# Broadstone 620/Birden Multi-Family Wastewater Service Extension Request #3880

Briefing to the Environmental Commission November 16, 2016

Kelly Gagnon Watershed Policy & Planning

## **Description of proposed extension:**

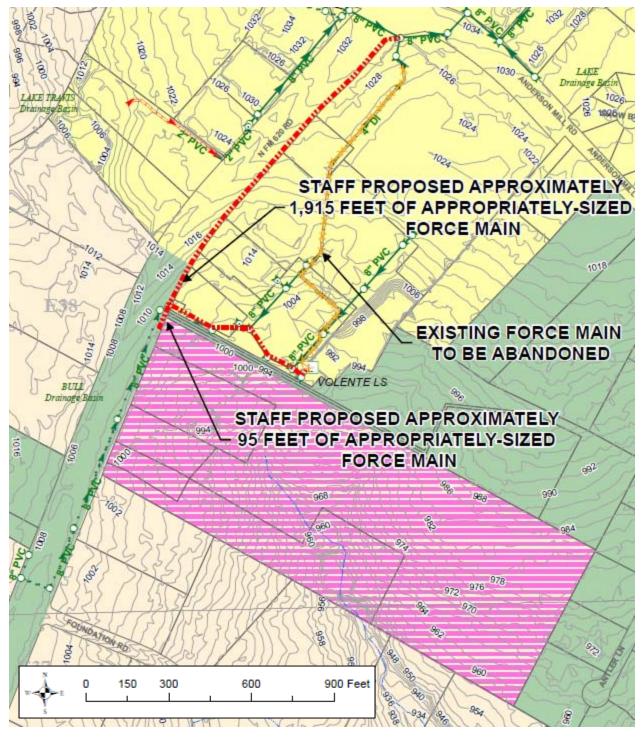
- Approximately 95 feet of wastewater force main extending from the existing gravity main in the FM 620 Rd right-of-way to the subject tract.
- Construction of a private, on-site lift station and force main.
- Upgraded pumping capacity of the existing Volente lift station to adequately serve additional wastewater flow to be contributed by the proposed development.
- Approximately 1,915 feet of wastewater force main from the existing gravity main at the intersection of N FM 620 Rd and Anderson Mill Rd south along N FM 620 and east to the Volente lift station.

## **Review Criteria: NEARBY EXTENSION REQUESTS**

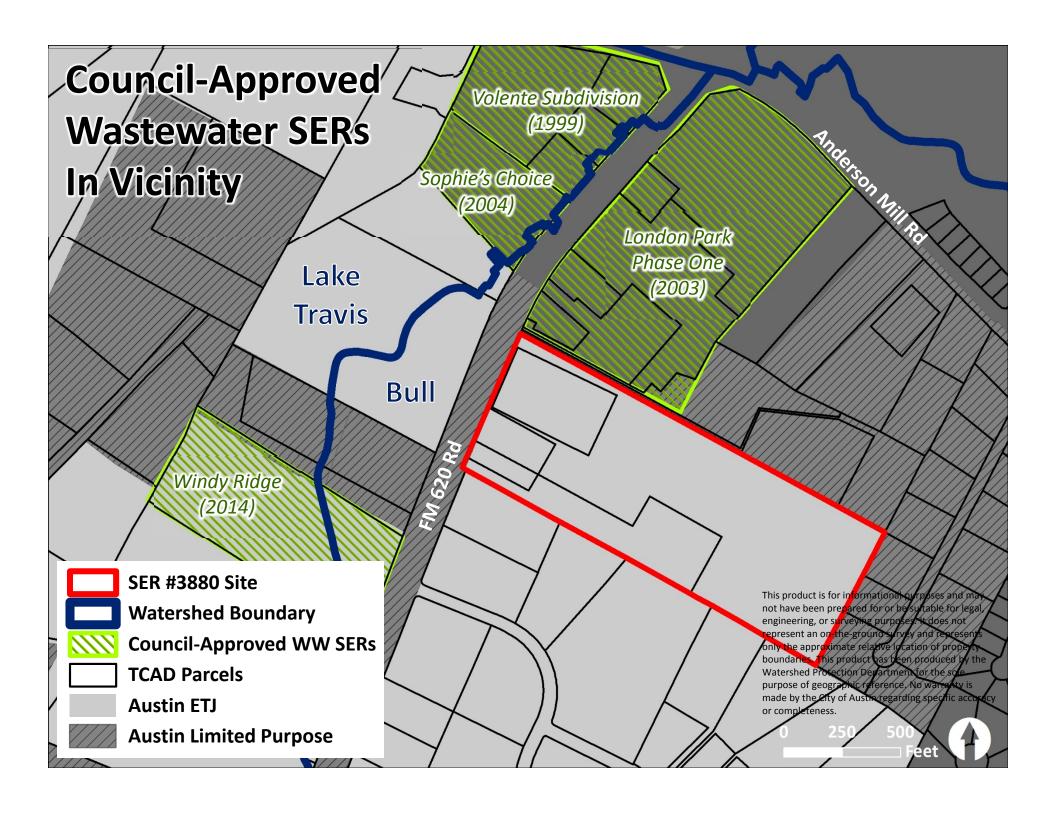
## Have similar SERs been granted in the vicinity?

Yes. Council has approved WW SERs to the north and west of the site.

# If so, does this development have any additional potential environmental issues to consider?

Yes. The entire site drains to JPS habitat and has critical features and headwaters on site.

The SERs approved to the north of the site were originally approved to allow Anderson Mill MUD temporary out-of-district service. These sites are now located in the COA full purpose jurisdiction.
